## Site Technical Query - Form

TQ Number:		Project:	
<b>CW2144960 -A010- 0051</b>		<b>Oyu Tolgoi Underground Project</b>	
A. To be completed by or on behalf of the Contractor			
Contractor/Sub-Contractor Name:	MCS International	Date Response	18/01/2022
Contract Title:	Booster Fan installations	Plant Area &	1693
Contract No.	CW2144960	Contractor TQ Number:	BF-0415-TQ-0051
Discipline Codes (Mandatory) D1 (CSA) - <input type="checkbox"/> D2 (MP) - <input checked="" type="checkbox"/> D3 (E&I) - <input type="checkbox"/> D4 (Other) - <input type="checkbox"/>			
Description of Technical Query (List affected drawings and specifications): <b>HVAC condenser 1693-SRM-2001-AHU-CNDA support</b> E-room HVAC Condenser 1693-SRM-2001-AHU-CNDA unit will be installed on top of 1693-SRM-2001-AHU-CNDB unit as per TQ-0045. Therefore, suitable base supports will be needed for the HVAC condenser 1693-SRM-2001-AHU-CNDA.			
<input type="checkbox"/> Routine <input checked="" type="checkbox"/> Urgent Refer Technical Query instructions

Proposed Action (List all attachments)  The contractor is proposed the following options. <ol style="list-style-type: none"><li>1. Install the 1693-SRM-2001-AHU-CNDA unit on t

#### Air Cooled Condenser Installation

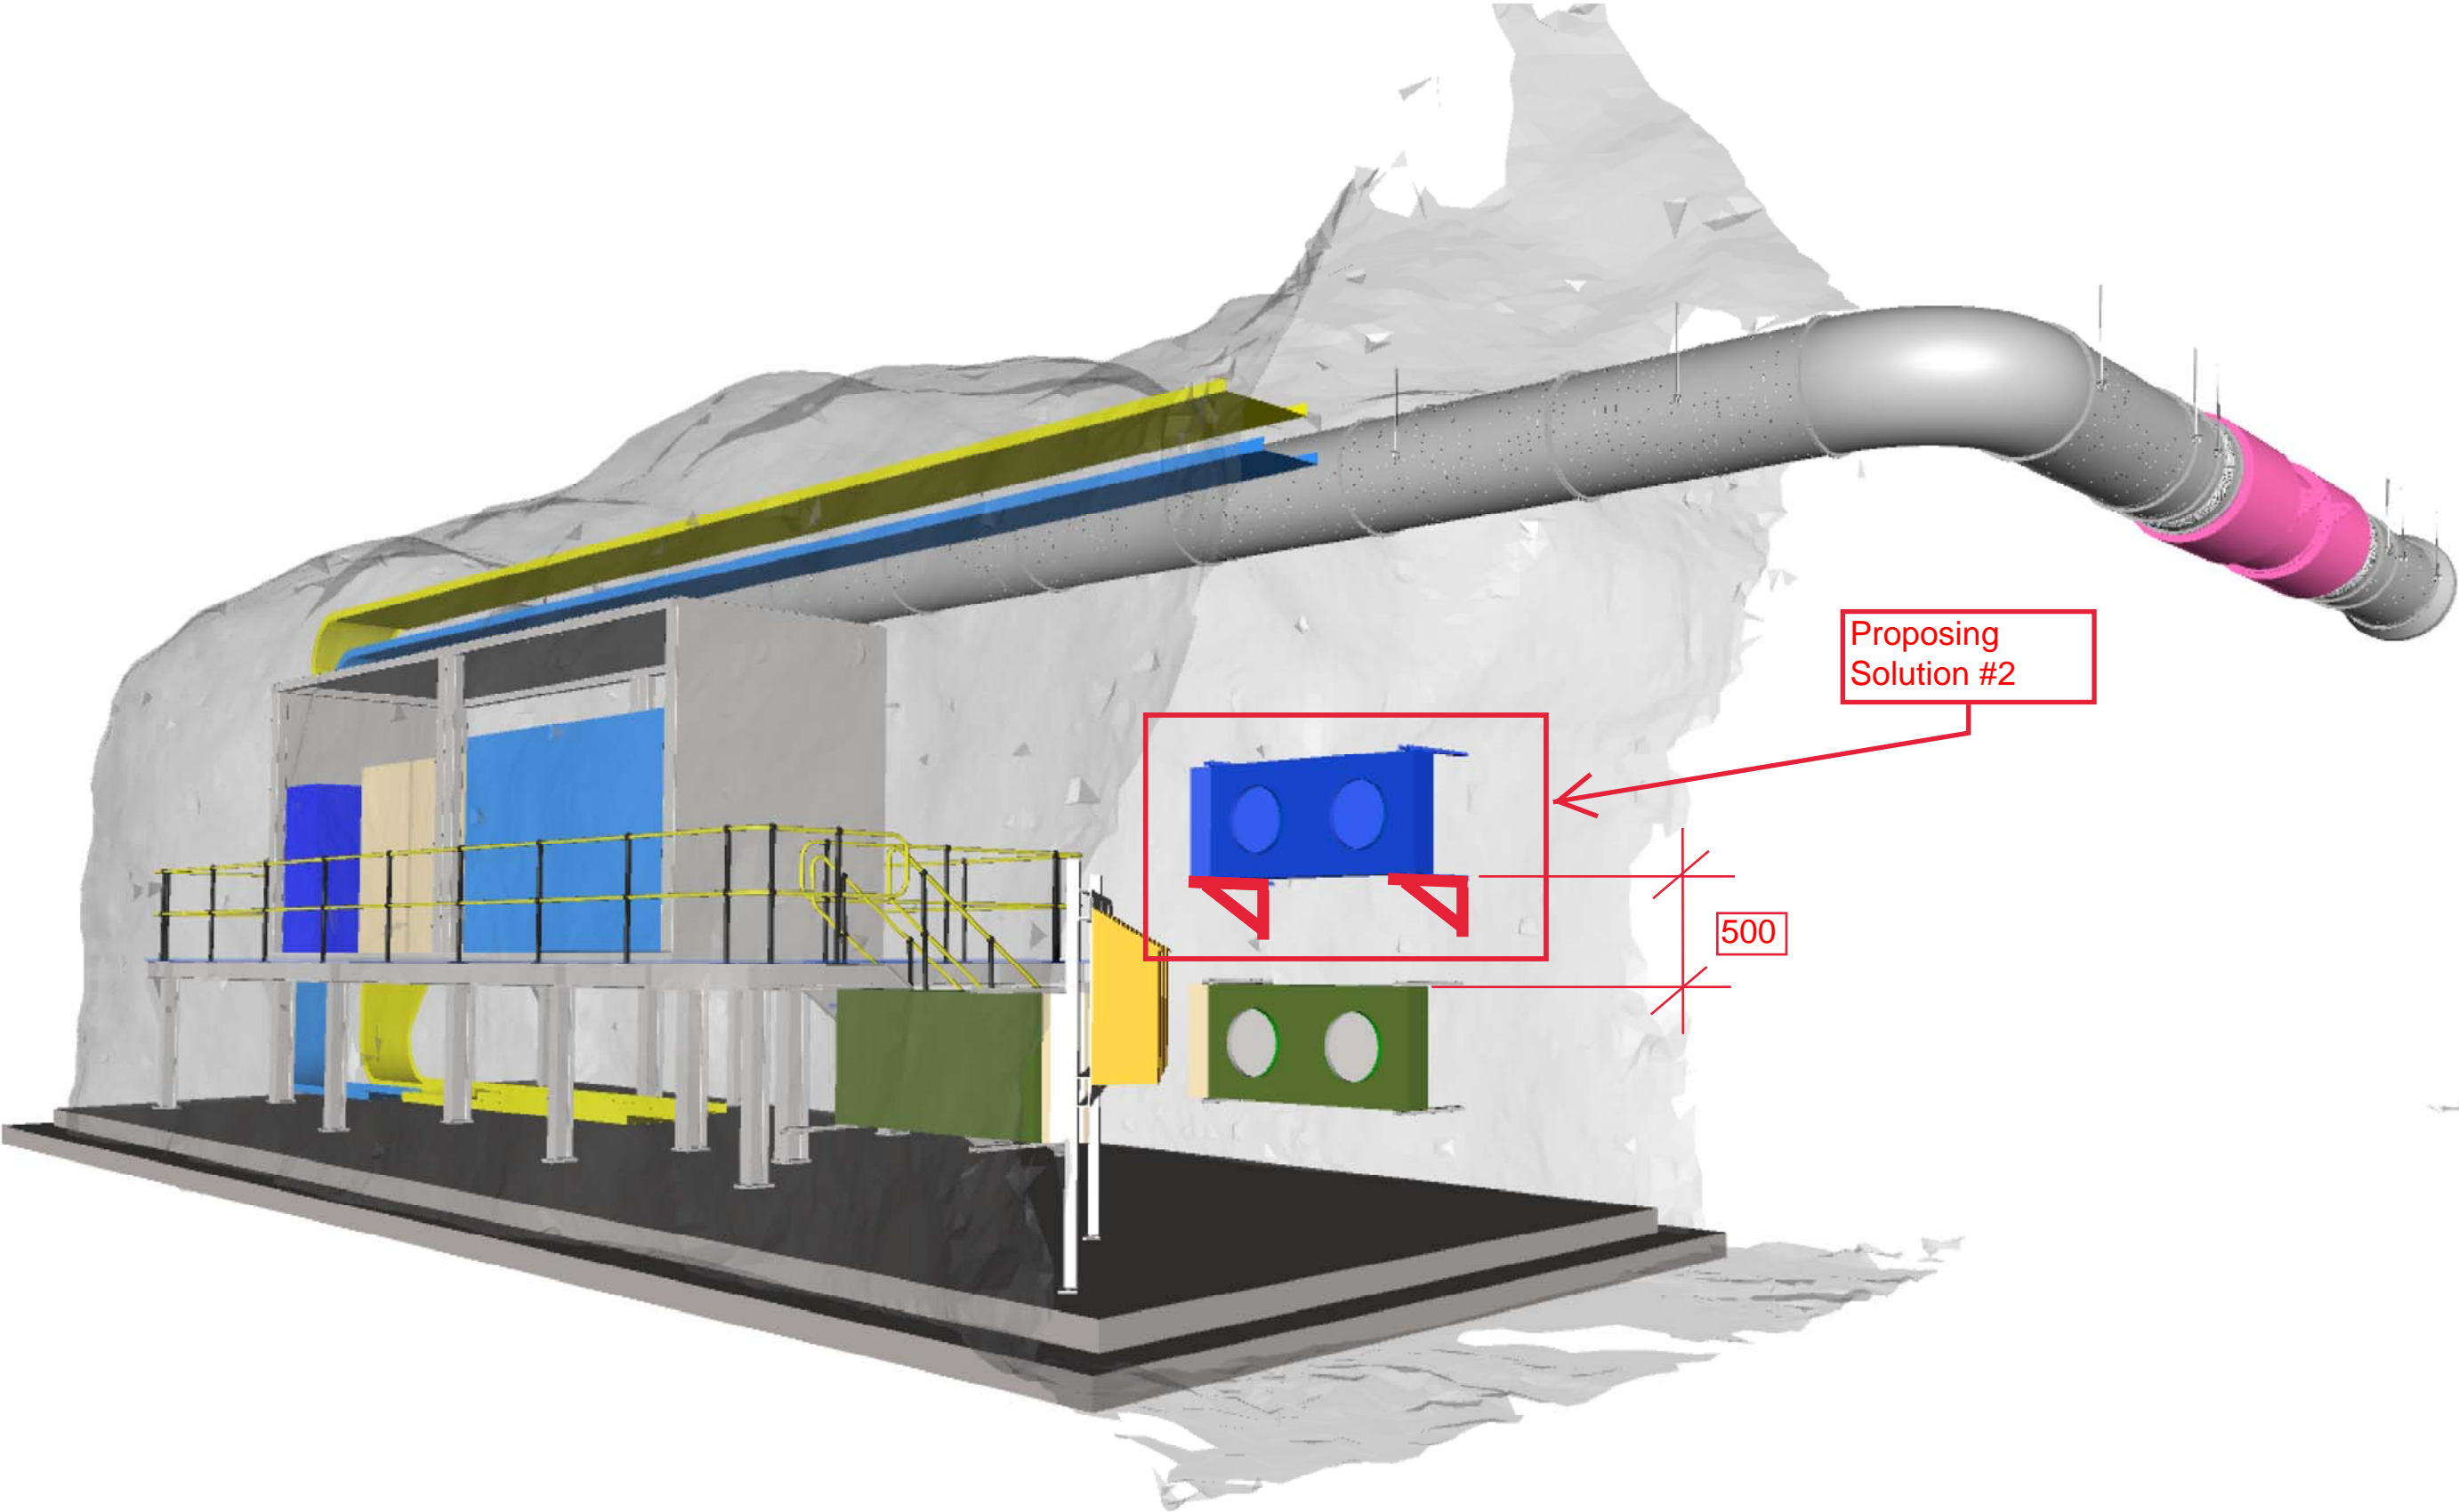
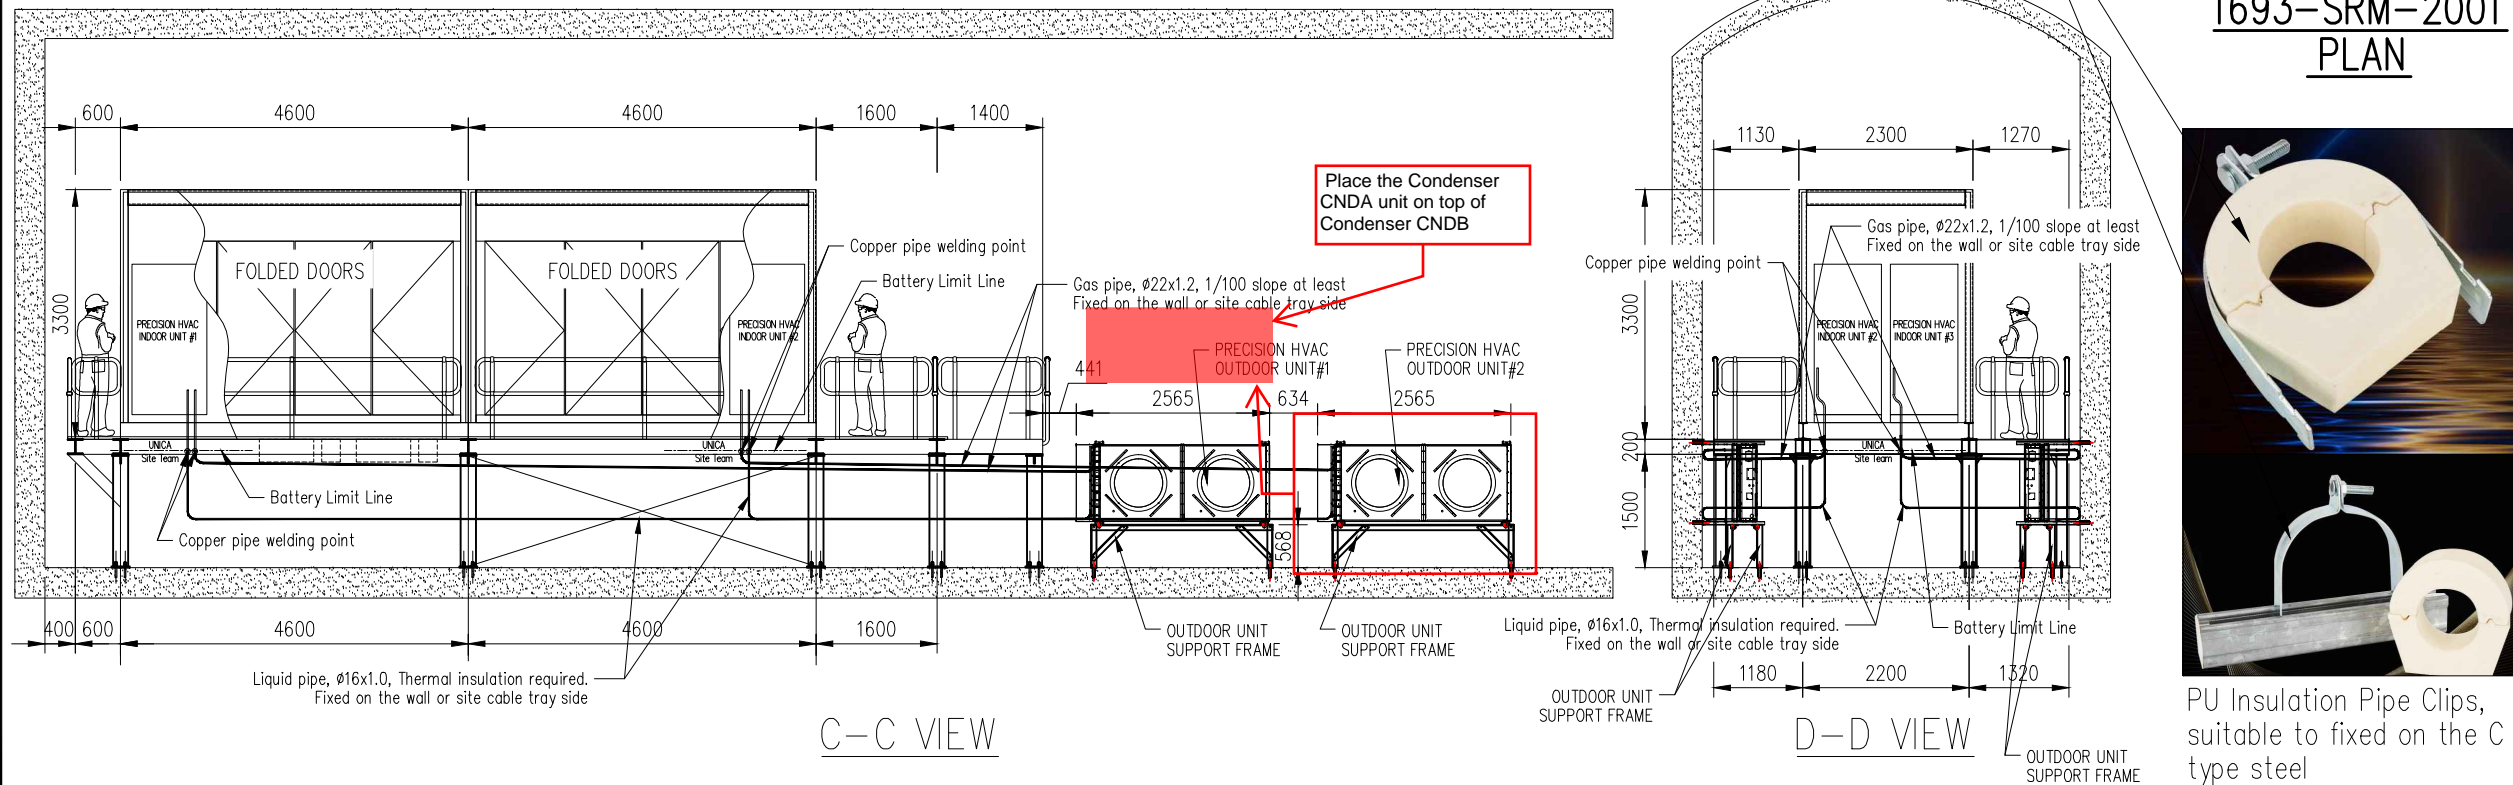
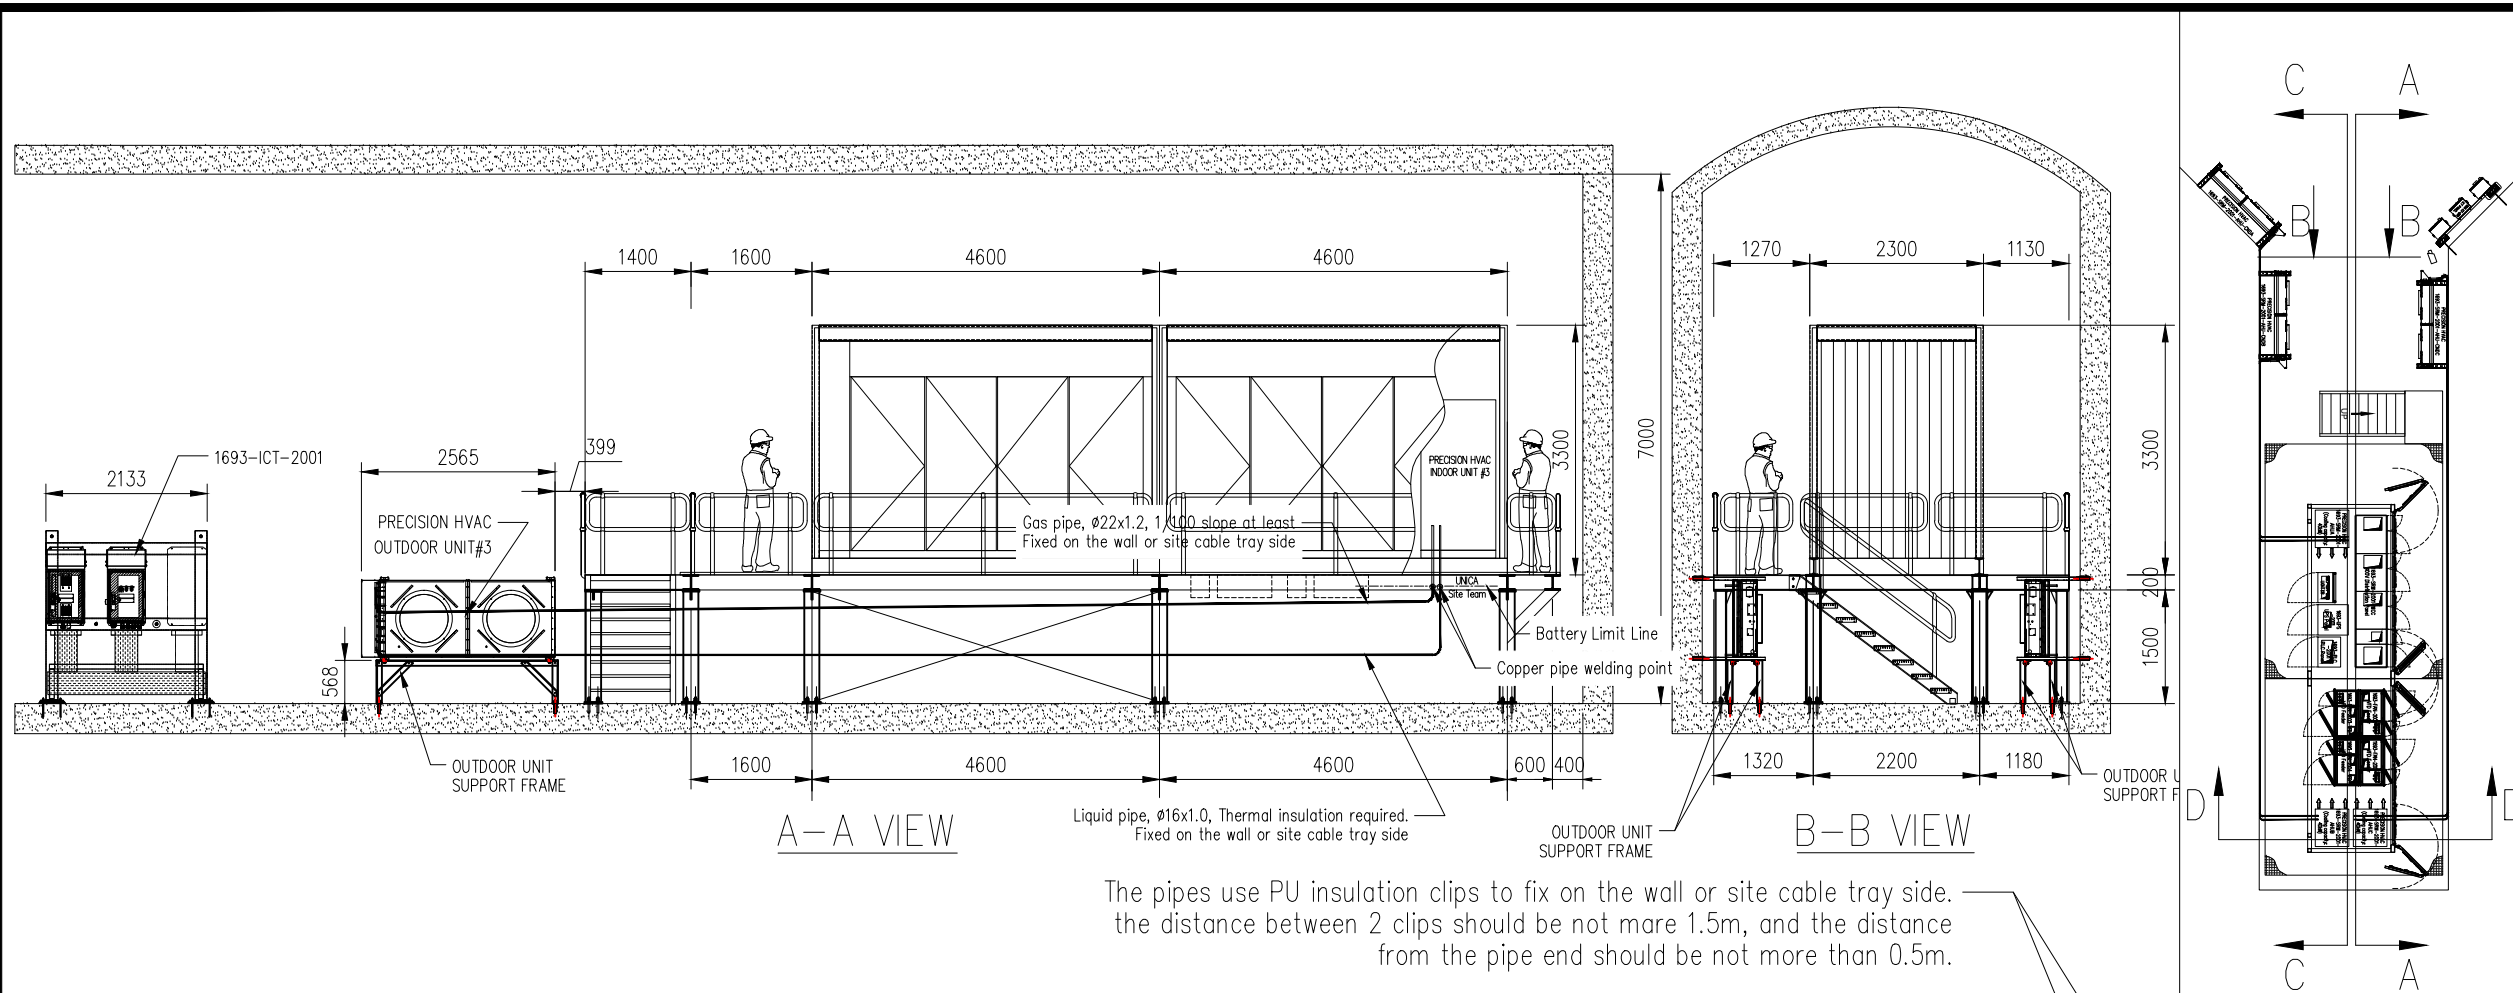
- This TQ is accepted only for location of the condenser unit 1693-SRM-2001-AHU-CNDA.
- The Contractor shall be provided gas and liquid pipe route as per Manufacturer recommendation which shows Page-77 on 1693-65-IOM-1500. Prior to installation, separate TQ shall required and confirmed by Worley Reps.

- The Contractor shall be provided Mounting Detail of this relocated condenser unit. Prior to installation, separate TQ shall required and confirmed by Worley Reps.
- Changes shall be redlined on all relevant drawings.
